TUNE UP MRT 50 EURO5

Code 0/000.770.0099

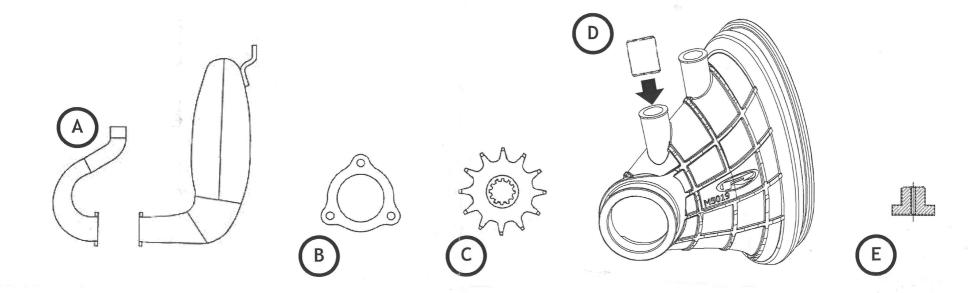
- 1.- Remove exhaust pipe elbow (A) and instead install exhaust pipe elbow and joint (B) received from kit.
- 2.- Replace sprocket © and instead install sprocket z14 received from Kit
- 3.- Remove all AIS VALVE components and insert spacers (D) on intake pipe to cover hole from AIS VALVE pipe.
- 4.- Replace serial max. jet and instead install max jet Ø90 received from Kit (E)
